**Volare Carburetors, LLC**

**Service Bulletin SB-4 Rev. B**

**SUBJECT: BOWL CLEARANCE MA- SERIES CARBURETORS**

**Applicability:** *This Service Bulletin (SB-4) applies to MA-2, MA-3, MA-4, MA-4-5, MA-4-5AA, MA-5, MA-5AA, MA-6 and MA-6AA model float carburetors manufactured by Volare Carburetors LLC (“Volare”), and its predecessors Precision Airmotive Corporation, Facet Aerospace Products Company, and Marvel-Schebler (Borg-Warner) (hereinafter “Volare”) that are equipped with a brass float assembly.*

**Fig. 1**

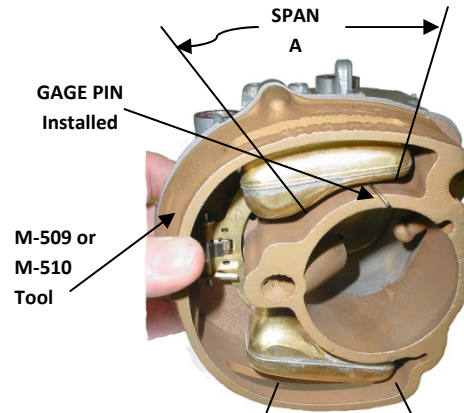
1. **Reasons:** **Warning:** **Failure to follow this advice may result in engine malfunction, damage, injury or death.** Reports of sticking, leaking and/or worn floats have been received, see Figure 1. The specified float/bowl clearance **MUST** exist to ensure proper operation.

**Fig. 2**

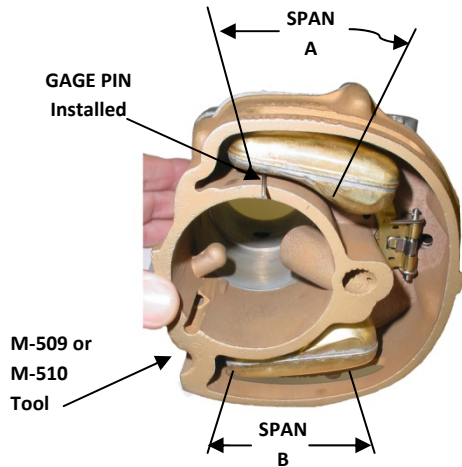
With the clearance tool M-510 used with the (MA-3, MA-4 series) or M-509 used with the (MA-5, MA-6, MA-4-5 Series) in place, orient the carburetor body with one pontoon uppermost, see Figure 2. Check the clearance between the float pontoon and the bowl wall. A .081 inch gage pin (models MA-2, MA-3 & MA-4), or a .051 gage pin (models MA-4-5, MA-4-5AA, MA-5, MA-5AA, MA-6 and MA-6AA) must pass between the lower surface of the upper pontoon and the throttle bore wall and between the lower surface of the lower pontoon and the lower bowl wall without touching either pontoon. Reorient the carburetor so that the other pontoon is uppermost, see Figure 3. Repeat the clearance check. If, as the gage pin is moved along between the float and the bowl wall the gage pin contacts either pontoon, float clearance is inadequate and the float assembly must be replaced.

**Fig. 6**

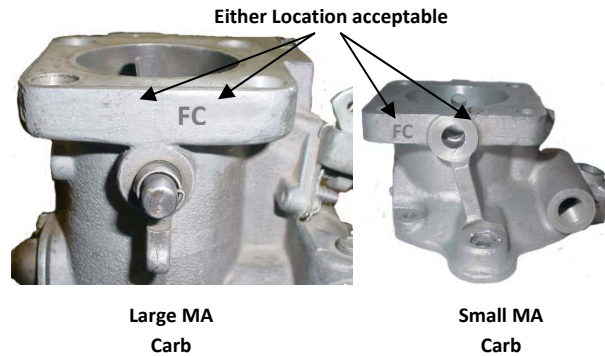
5. **Identification/Marking:** Upon completion of this Flight Safety Service Bulletin, stamp the letters "FC" ( $\frac{1}{8}$  inch tall (nominal) characters) on the flange adjacent to the throttle shaft, see Figure 6.
